Subject: Duke Energy Carolinas, LLC.
William States Lee III Nuclear Station - Docket Nos. 52-018 and 52-019
AP1000 Combined License Application for the
William States Lee III Nuclear Station Units 1 and 2
Response to Request for Additional Information
(RAI No. 1473)
Ltr# WLG2008.12-28

Reference: Letter from Brian Hughes (NRC) to Peter Hastings (Duke Energy),
*Request For Additional Information Letter No. 044 Related To SRP
Section 02.05.04 – Stability of Subsurface Materials and Foundations
Application for the William States Lee III Units 1 and 2 Combined License
Application, dated October 29, 2008*

Lee Nuclear Station Response to Request for Additional Information (RAI)

FIGURE 5 Rev 0

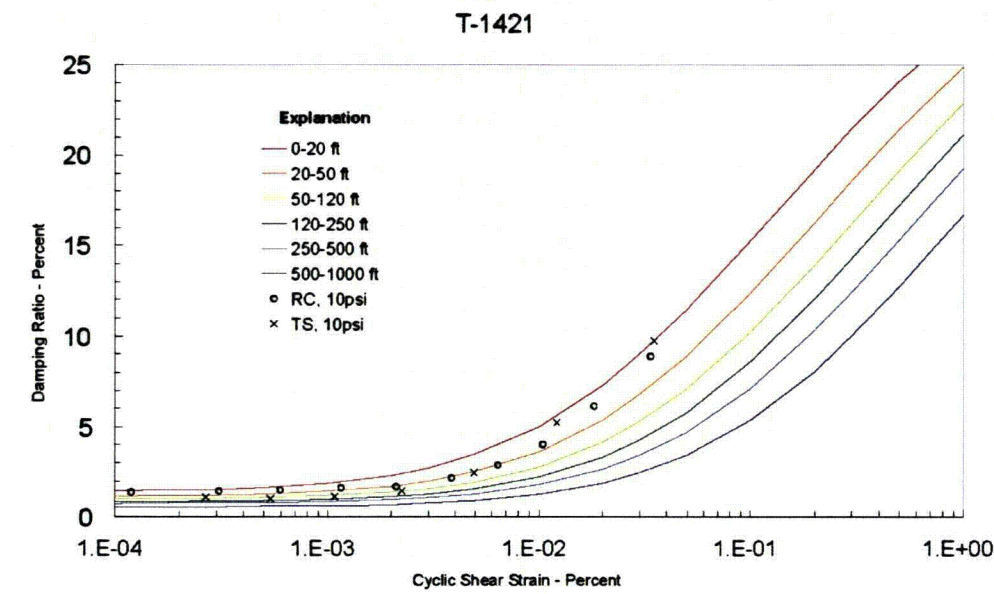
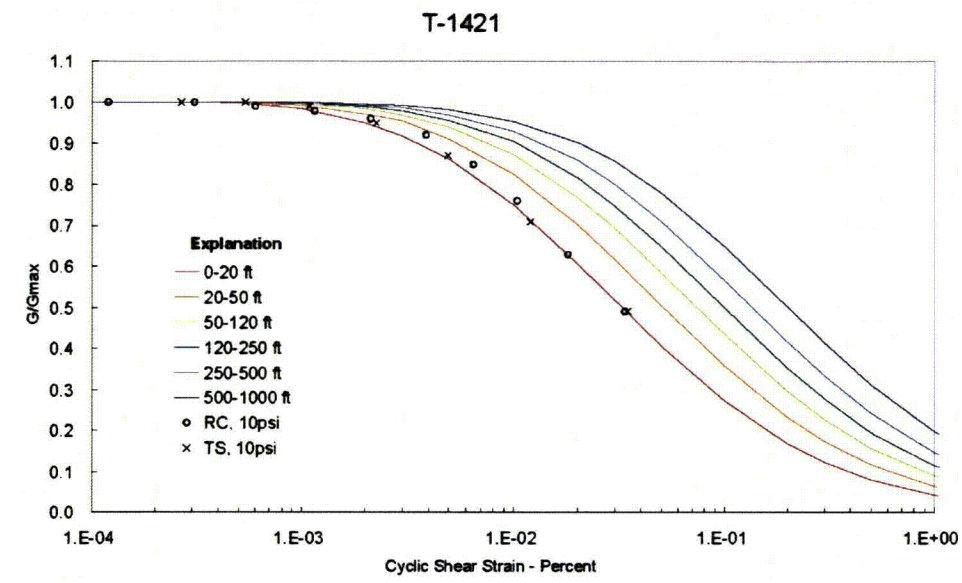
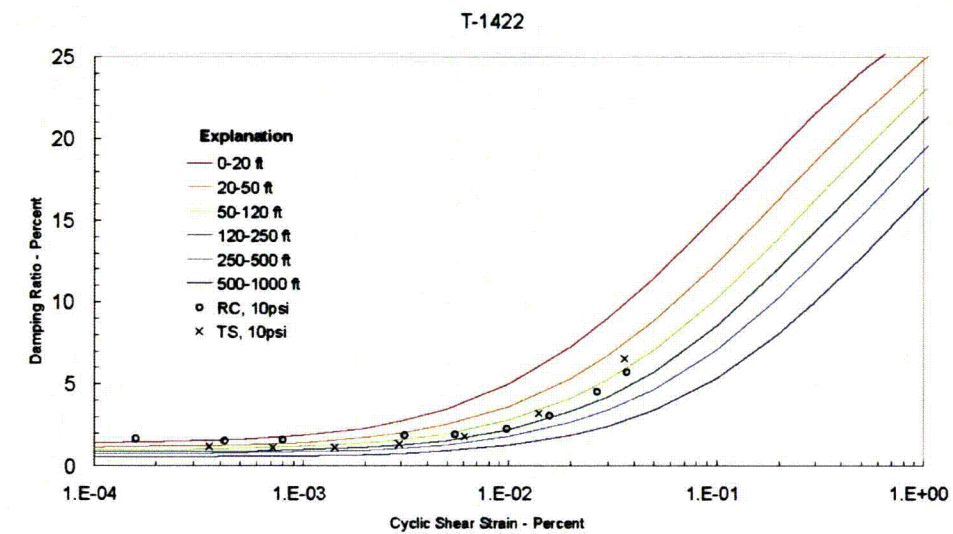
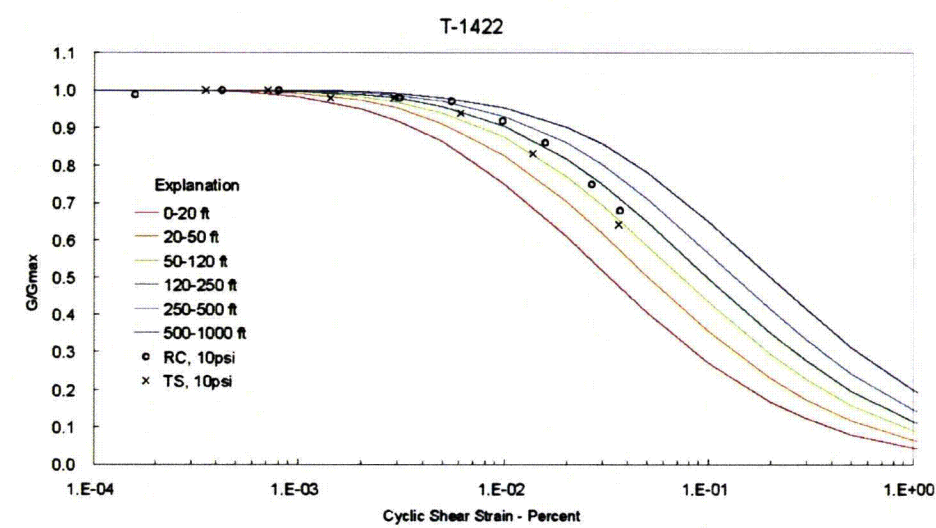
In FSAR Section 2.5.4.7, "Response of Soil and Rock to Dynamic Loading," Figures 2.5.4-253 2.5.4-254, you present the RCTS testing performed in conformance with the requirements of Regulatory Guide 1.138. There is variability in the RCTS test data over the range of testing pressures and the plotted test data lie outside beyond the limits of the two selected EPRI curves. Please justify how the selected curves represent the site-specific test data.

The RCTS lab testing was performed on a range of isotropic pressures to bracket estimates of in-situ confining pressure (K_0). The K_0 values used for sample testing were estimated values. The K_0 for compacted fill is estimated to be 0.9 (FSAR 2.5.4.10.3). The laboratory-measured small strain shear modulus shear wave velocity, G_{\max} (V_s), value from the RCTS tests should approximately agree with the field-measured in-situ V_s value at the corresponding depth if the K_0 assumption is approximately correct and if the effect of aging on the in-situ G_{\max} is relatively minor. The laboratory and in-situ V_s values were compared at small strain conditions to estimate if the RCTS tests at 1X estimated confining stress in-situ (σ_o) using $K_0 = 1$ appear to be representative of the in-situ measured V_s . The evaluation of the lab-measured V_s to field-measured V_s for the existing Group I engineered fill, samples, B-1068-UD, S-3 (Figure 1) and B-1068-UD, S-5, (Figure 2) show good correlation using the lab mean confining stress to represent the in-situ confining stress at K_0 equal to 1 (field V_s 750fps/lab V_s 870 fps) and (field V_s 740fps/lab V_s 788 fps), respectively. Therefore, the lab tests at 1X estimated in-situ confining stress are considered representative of the in-situ condition.

The factors considered in matching results of the RCTS tests with the appropriate EPRI curves included the material index properties, groundwater conditions, depth of sample, and potential thickness of fill. Because the soil types considered for backfill are generally low plasticity to nonplastic, the sand curves as presented in FSAR Figures 2.5.4-253 and 2.5.4-254 were selected. Figures 3 through 7 describe shear modulus and damping ratio plots for two Existing Group I Engineered Fill and three Remolded Samples at 1X in-situ confining stress, (σ_o estimated with K_o equal to 1). These plots justify the selection of the two EPRI curves, 0-20 feet and 20-50 feet, as described in FSAR Subsection 2.5.4.7.3. The selected curves span the observed range of dynamic properties and are used to evaluate site-specific epistemic variability of proposed Group I engineered fill. For site response analyses (Reference 1) of non-Category I structures founded on or over compacted Group I engineered fill over continuous rock, or Group I engineered fill over saprolite soils overlying partially weathered / continuous rock, the process used in evaluating epistemic variability adequately accounts for the minor differences in the test curves and the two EPRI curves. One remolded sample, T-1422, Figure 7, is somewhat inconsistent with the EPRI curve but this is not considered significant since this is only one out of the five RCTS tests representing the future Group I engineered backfill.

Revised FSAR Figure 2.5.4-229, Boring Summary Sheet, B-1070, Rev. 1

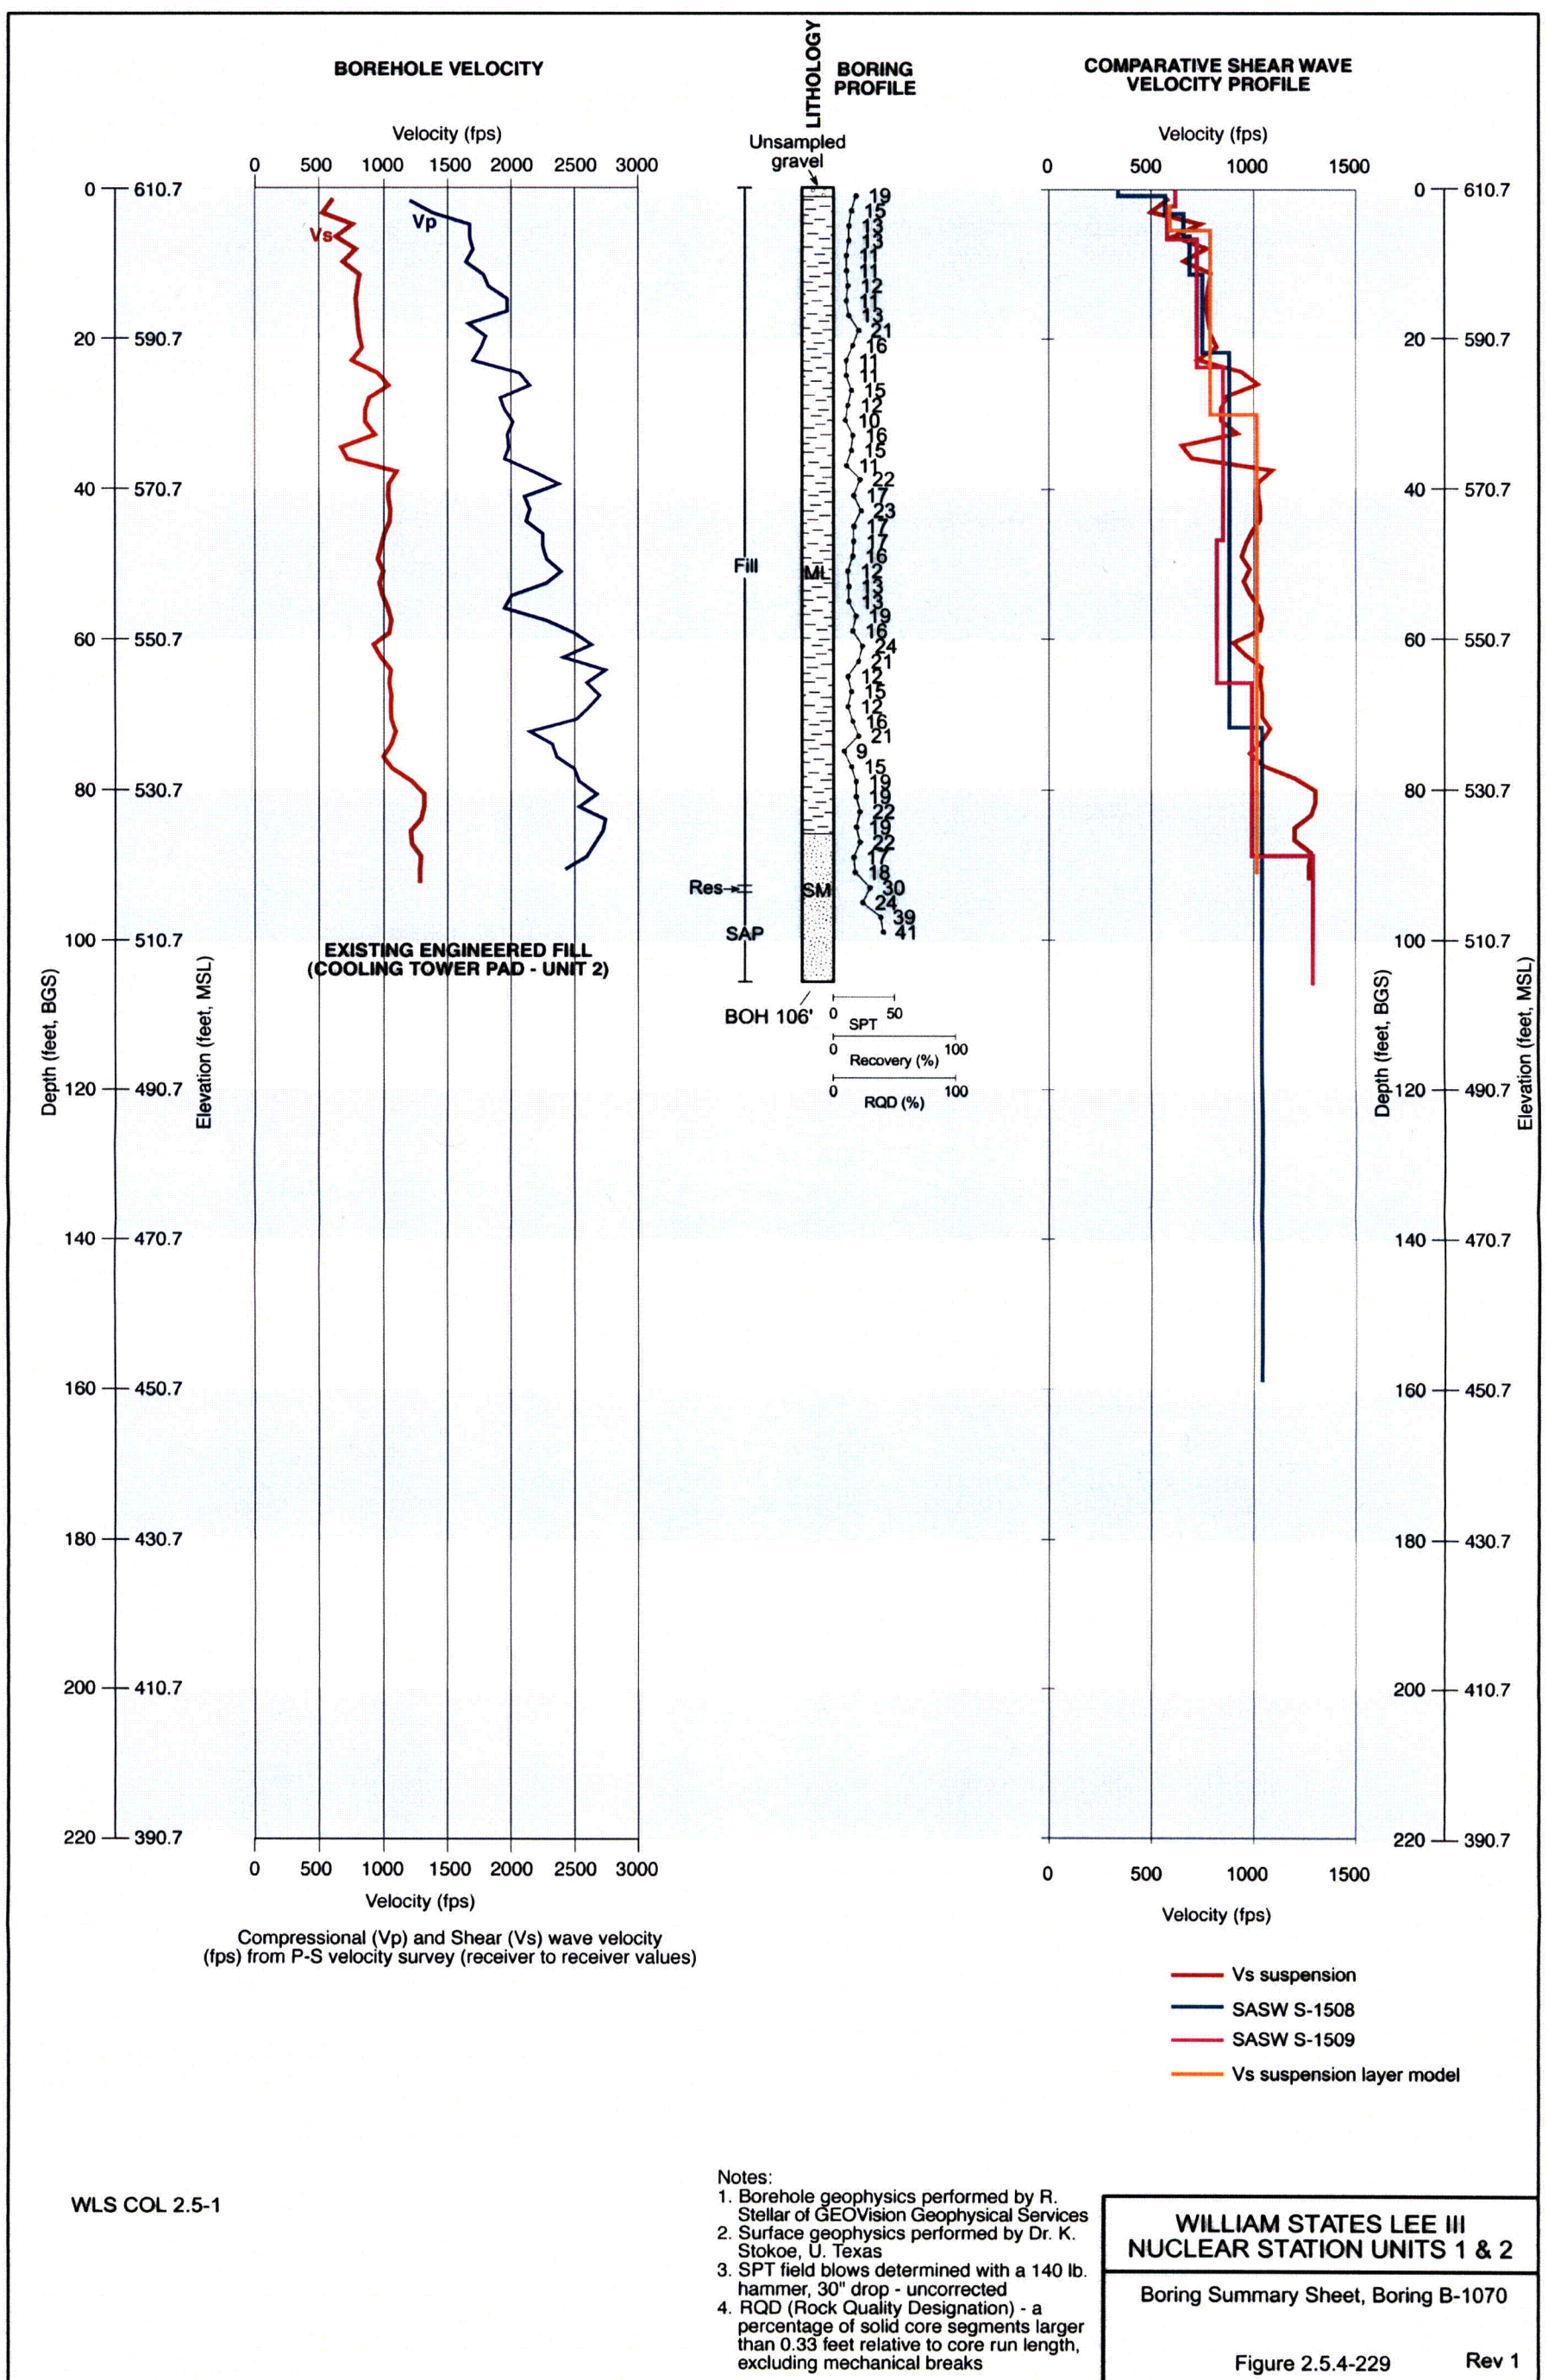
FSAR Figure 2.5.4-229, left-side, shows two different scales along the X-axes, top and bottom. Please correct the figure.

The editorial error in the X-axis scale is corrected in the attached markup of FSAR Figure 2.5.4-229. This updated figure will be included in a future FSAR revision.
